Project	IEEE 802.16 Broadband Wireless Access Working Group < http://ieee802.org/16 >	
Title	MAC Messages supporting the CSI	
Date Submitted	2006-11-15	
Source(s)	Wu Xuyong, Huawei Huawei Industrial Base, Bantian, Longgang, Shenzhen 518129 P.R.C	Voice: +86-755-28972327 Fax: wuxuyong@huawei.com
Re:	80216h-06_059: IEEE 802.16 Working Group Working Group Letter Ballot #24 (2006-10-11)	
Abstract	Discuss the MAC messages supporting the CSI, such as DCD, DL-MAP etc.	
Purpose	To consolidate the working document.	
Notice	This document has been prepared to assist IEEE 802.16. It is offered as a basis for discussion and is not binding on the contributing individual(s) or organization(s). The material in this document is subject to change in form and content after further study. The contributor(s) reserve(s) the right to add, amend or withdraw material contained herein.	
Release	The contributor grants a free, irrevocable license to the IEEE to incorporate material contained in this contribution, and any modifications thereof, in the creation of an IEEE Standards publication; to copyright in the IEEE's name any IEEE Standards publication even though it may include portions of this contribution

Proposed changes on figure-h14 and h15

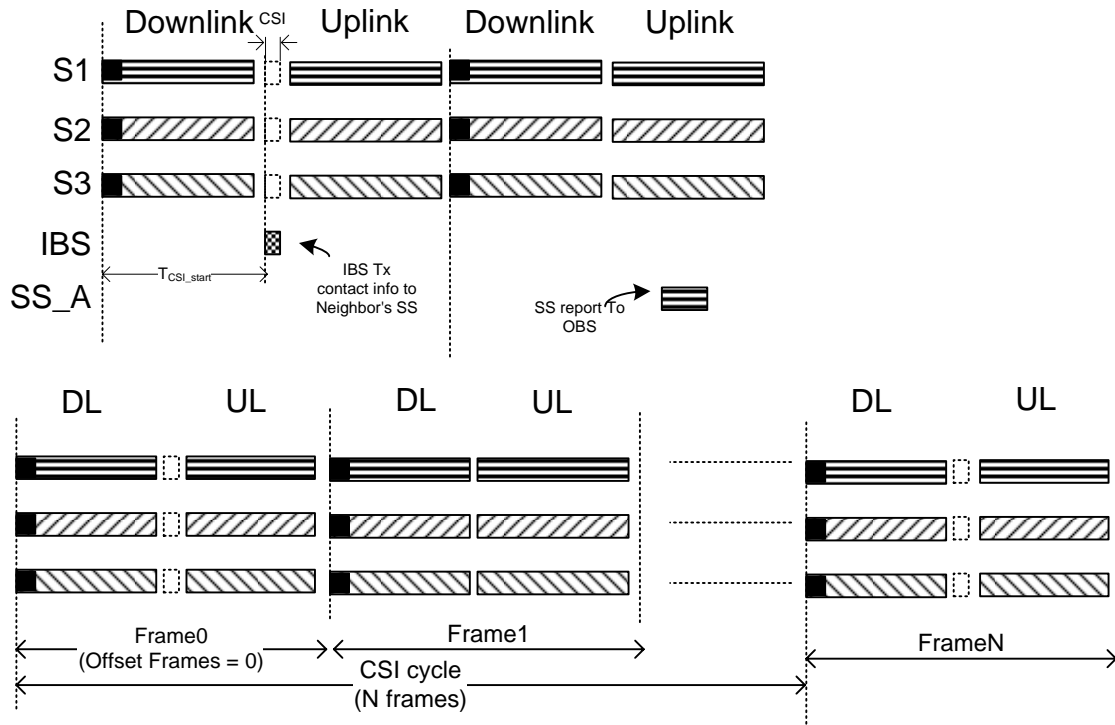
Proposed changes on figure-h29 and h30
